SUBJECT: DRESDEN NUCLEAR POWER STATION, UNITS 2 AND 3 - STAFF
ASSESSMENT OF INFORMATION PROVIDED PURSUANT TO TITLE
10 OF THE *CODE OF FEDERAL REGULATIONS* PART 50, SECTION 50.54(f),
SEISMIC HAZARD REEVALUATIONS RELATING TO RECOMMENDATION 2.1
OF THE NEAR-TERM TASK FORCE REVIEW OF INSIGHTS FROM THE
FUKUSHIMA DAI-ICHI ACCIDENT (TAC NOS. MF3877 AND MF3878)

STAFF ASSESSMENT BY THE OFFICE OF NUCLEAR REACTOR REGULATION

RELATED TO SEISMIC HAZARD AND SCREENING REPORT

DRESDEN NUCLEAR POWER STATION, UNITS 2 AND 3

Figure 3.3-1 Plot of Staff's and Licensee's Base Case Shear-Wave Velocity Profiles: (a) Velocity profiles to a depth of 5000 ft [1524 m], (b) Velocity profiles to a depth of 500 ft [152 m] for the Dresden site

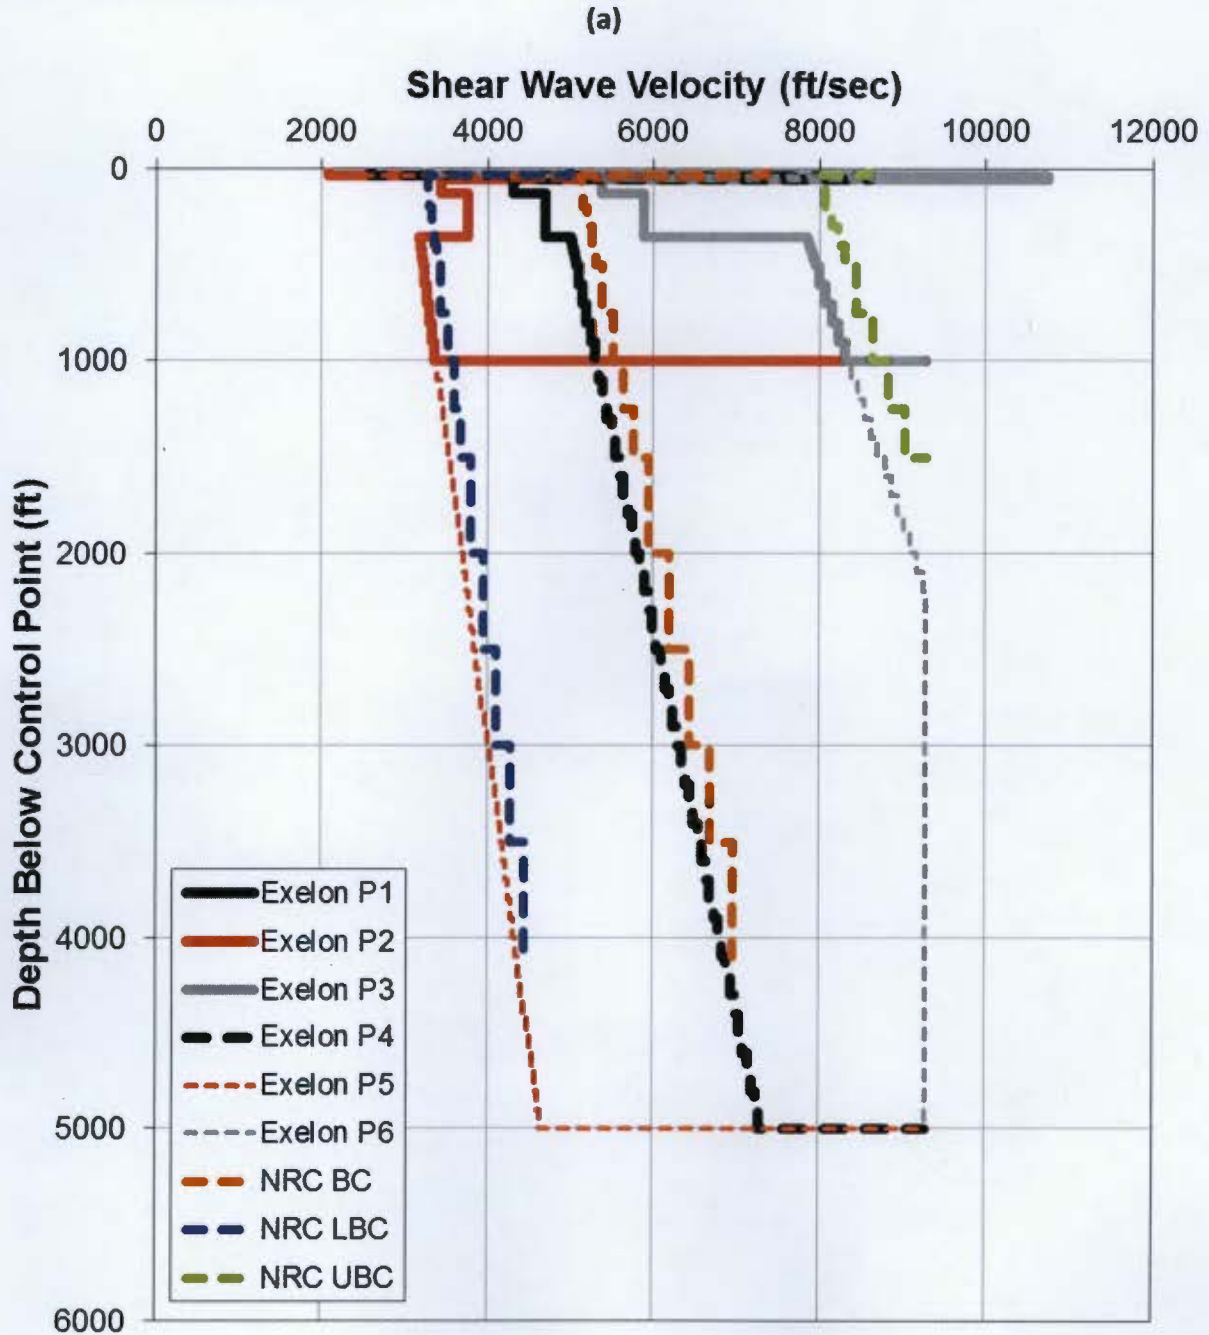
For each of these two best estimate profiles with different depths to the base rock layer, the licensee developed upper and lower base case profiles for a total of six site base case profiles. The licensee developed the upper and lower base case profiles for each of the two best estimate profiles using a natural log standard deviation of 0.20 for the upper 360 ft [110 m] and 0.35 for greater depths. Figure 3.3-1 of this assessment shows the licensee's shear-wave velocity base case profiles.

Because limited velocity information is available for the Dresden site, the staff used three shear wave velocity profiles. For the depth interval between the control point and 50 ft [15 m] below the control point, the staff used an average of the measured compression wave velocities and then assumed a Poisson's ratio to develop its shear wave velocity profile. For depths between 50 ft [15 m] below the control point and the base of the profile, the staff assumed the shear wave velocity increased linearly, consistent with guidance from the SPID. To capture the uncertainty in the depth to base rock, the staff used a depth of 4,100 ft [1250 m] for its lower and middle base case profiles and a depth to base rock of 1,500 ft [457 m] for its upper base case profile. The staff introduced additional uncertainty in the depth to base rock by randomizing the depth to base rock by ± 30 percent of the total profile thickness. Figure 3.3-1 of this assessment shows the staff velocity profiles compared to the profiles developed by the licensee.

The largest difference between the staff's and licensee's velocity profiles is in the upper 35 to 360 ft [11 – 110 m], which is primarily due to defining the control point at slightly different elevations and the staff applying larger uncertainty to develop its lower and upper base case profiles. Regarding the control point elevation, the reactor building foundation is supported on Ordovician Divine limestone at an elevation of 472.5 ft [144 m]. The staff used the top of this geologic unit as the control point, while the licensee used the top of the uppermost rock unit, the Pennsylvanian Pottsville Formation sandstone as the control point (515 ft [74.7 m]). Additionally, rather than develop six base case profiles, the staff developed only three profiles, as described above. To develop its lower and upper base case velocity profiles, the staff used a natural log standard deviation of 0.35, which is the value recommended by the SPID for sites with limited subsurface data.

Figure 3.3- 1 Plot Comparing the Staff's and the License's Median Amplification Functions and Uncertainties for two input loading levels for the Dresden site

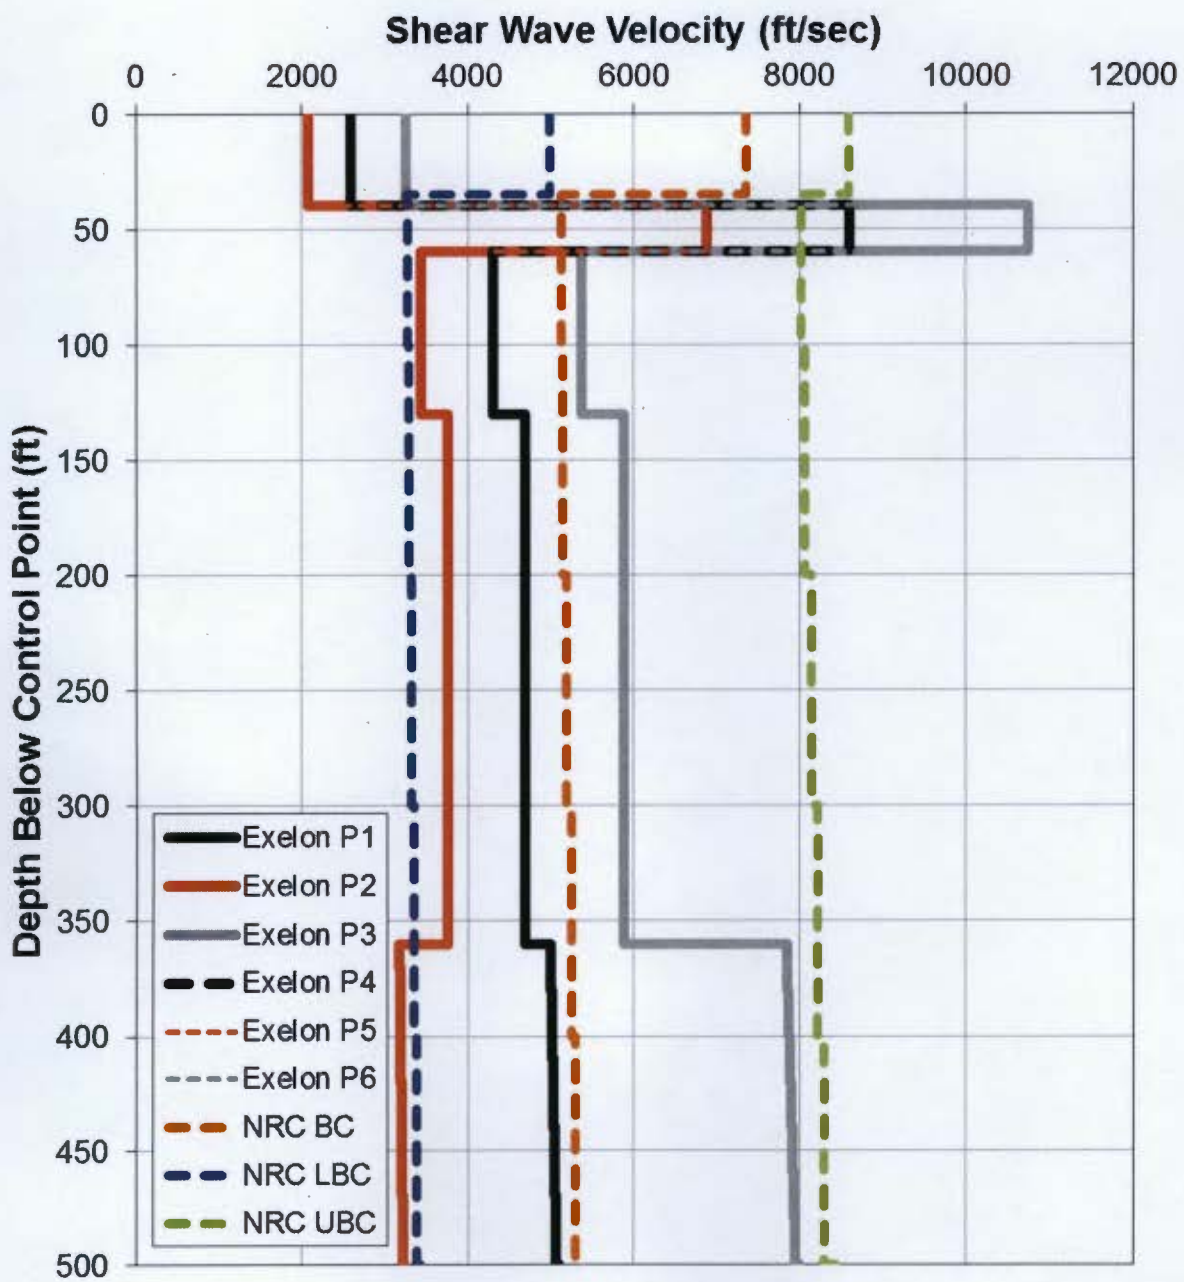
Figure 3.3-2 of this assessment shows a comparison of the staff's and licensee's median site amplification functions and uncertainties (± 1 standard deviation) for two of the eleven input loading levels. The comparison of amplification functions is for the licensee's profile P1 and the staff's base case profile. The licensee's amplification functions are moderately higher than the staff's amplification functions near 1 Hz and between 5 – 15 Hz. The differences above 5 Hz are primarily due to the different control point elevations assumed by the staff and licensee while the differences at 1 Hz are due to the licensee's use of two sets of profiles with different depths to bedrock at 1,000 ft [305 m] and 5,000 ft [1524 m]. The staff used a depth to base rock of 4,100 ft [1250 m] for its lower and middle base case profiles and a depth to base rock of 1,500 ft [YYY m] for its upper base case profile.

Overall, the licensee's approach to modeling the subsurface rock properties and their uncertainty results in higher site amplification factors, particularly at high frequencies. As shown in Figure 3.3-3 of this assessment, these differences in the site response analysis do not have a significant impact at 1 Hz and only a moderate impact above 5 Hz on the control point seismic hazard curves and the resulting GMRS, as discussed below. Appendix B of the SPID provides guidance for performing site response analyses, including capturing the uncertainty for sites with less subsurface data; however, the guidance is neither entirely prescriptive nor comprehensive. As such, alternative approaches in performing site response analyses, including the modeling of uncertainty, are acceptable for this application.

Figure 3.3-2 Plot Comparing the Staff's and the Licensee's Mean Control Point Hazard Curves at a Variety of Frequencies for the Dresden site

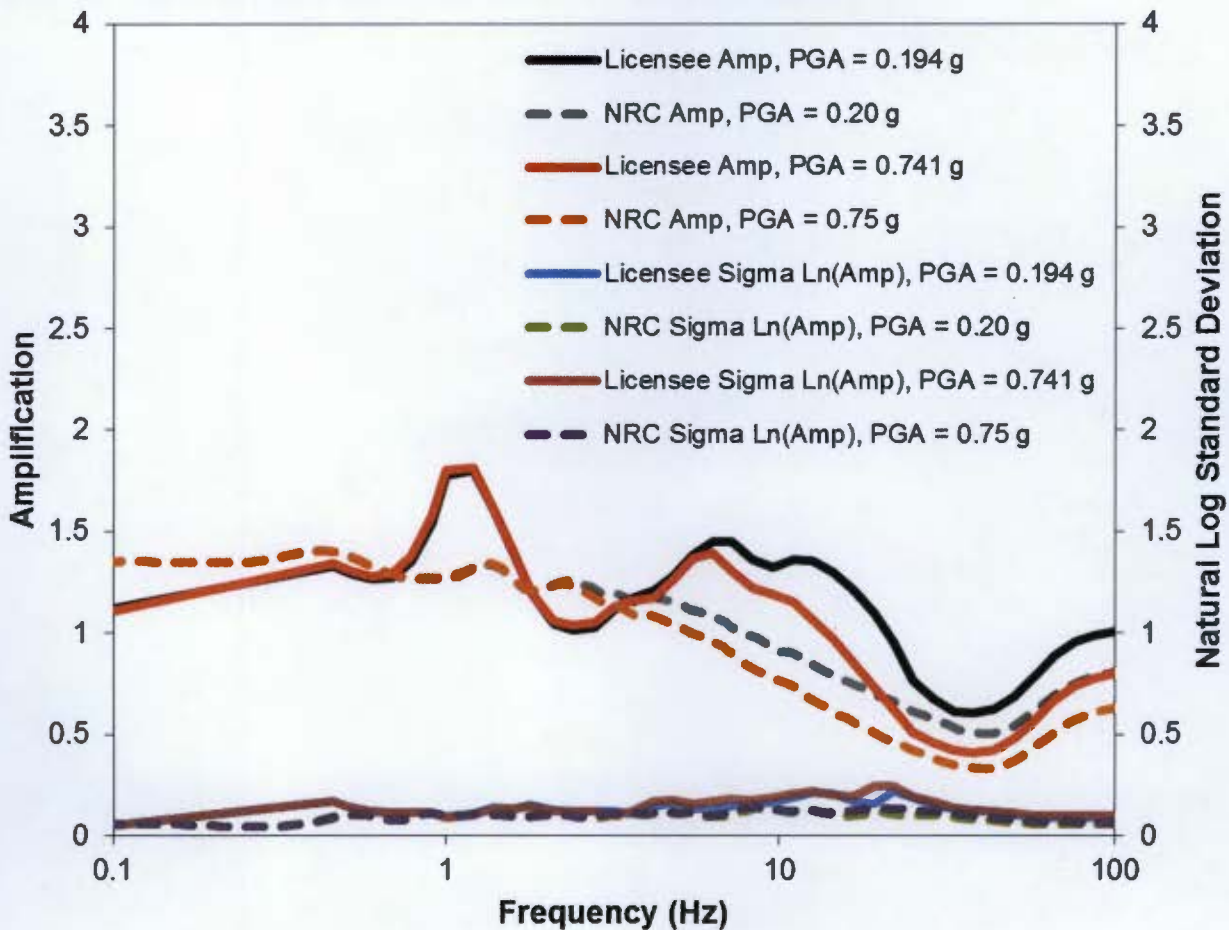
In summary, the staff concludes that the licensee's site response was conducted using present-day guidance and methodology, including the NRC-endorsed SPID. The staff performed independent calculations to confirm that the licensee's amplification factors and control point hazard curves adequately characterize the site response, including the uncertainty associated with the subsurface material properties, for the Dresden site.

Figure 3.4-1 Comparison of the Staff's GMRS with Licensee's GMRS and the SSEs for the Dresden site

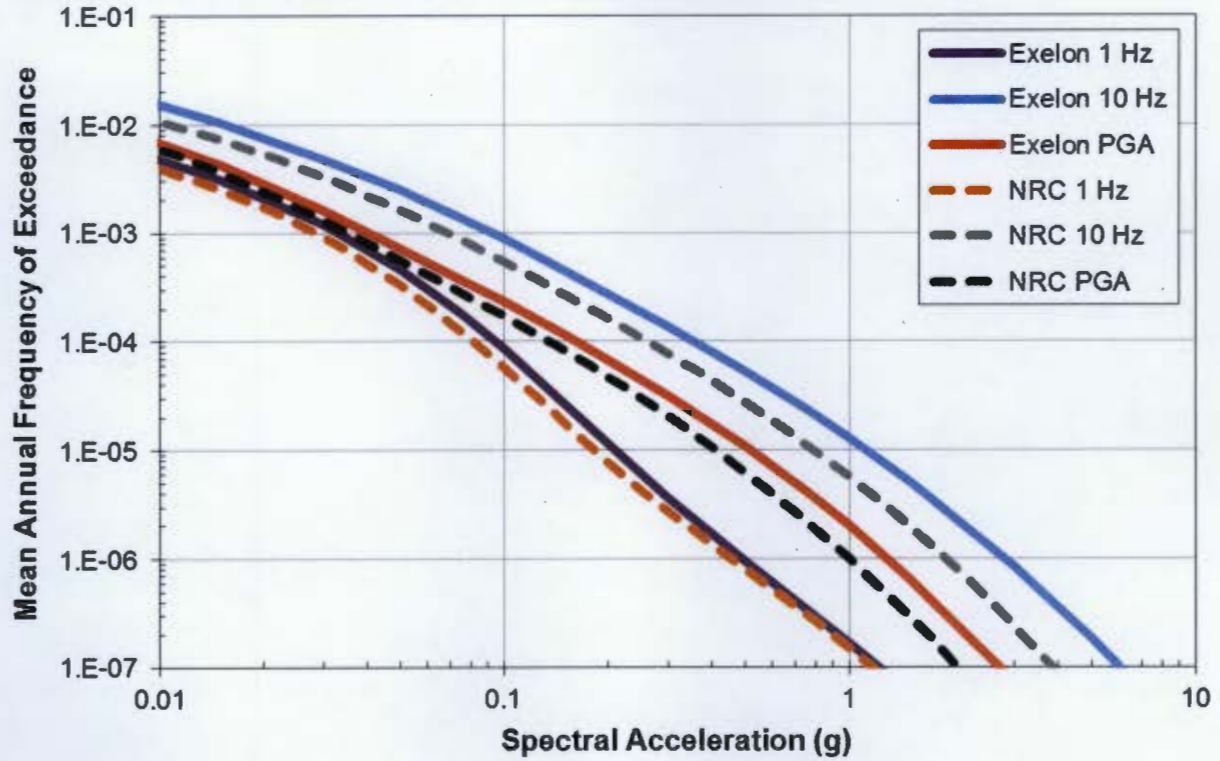
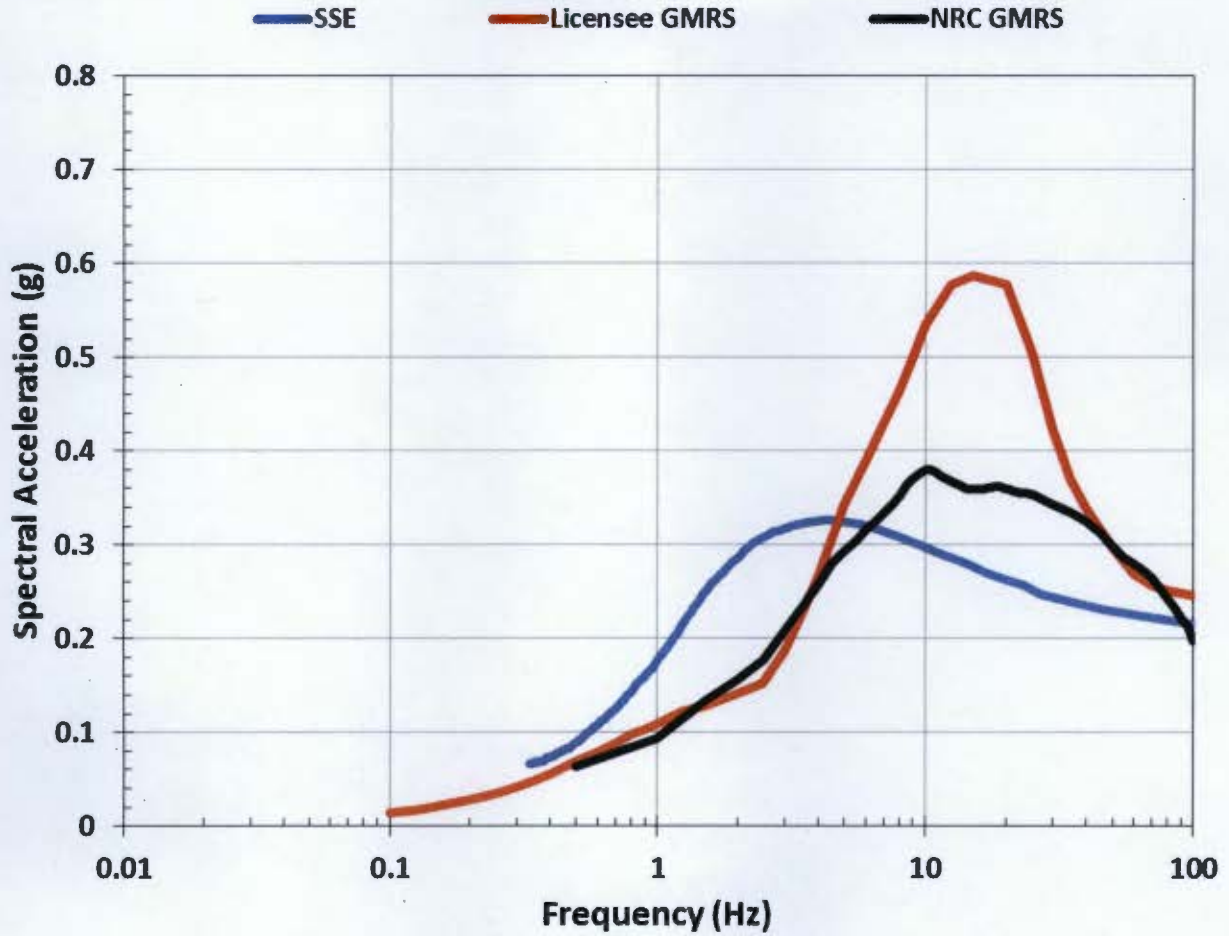
The staff independently calculated the 10^{-4} and 10^{-5} UHRS using the results of its confirmatory PSHA and site response analyses, as described in Sections 3.2 and 3.3 of this staff assessment, respectively. Figure 3.4-1 of this assessment shows a comparison of the GMRS determined by the licensee to that determined by the staff.

As shown in Figure 3.4-1 below, the licensee's GMRS shape is generally similar to that calculated by the staff at frequencies less than 5 Hz. However, NRC staff's confirmatory GMRS is somewhat lower than the licensee's at frequencies above 5 Hz. As described above in Section 3.3, the staff concludes that these differences over the higher frequency range are primarily due to the differences in the site response analyses performed by the licensee and staff. The staff concludes that these differences are acceptable for this application because the licensee followed the guidance provided in the SPID with respect to both the PSHA and site response analysis for the Dresden site.

The staff confirms that the licensee used the present-day guidance and methodology outlined in RG 1.208 and the SPID to calculate the horizontal GMRS, as requested in the 50.54(f) letter. The staff performed both a PSHA and site response confirmatory analysis and achieved results generally consistent with the licensee's horizontal GMRS. As such, the staff concludes that the GMRS determined by the licensee adequately characterizes the reevaluated hazard for the Dresden site. Therefore, this GMRS is suitable for use in subsequent evaluations and confirmations, as needed, for the response to the 50.54(f) letter.
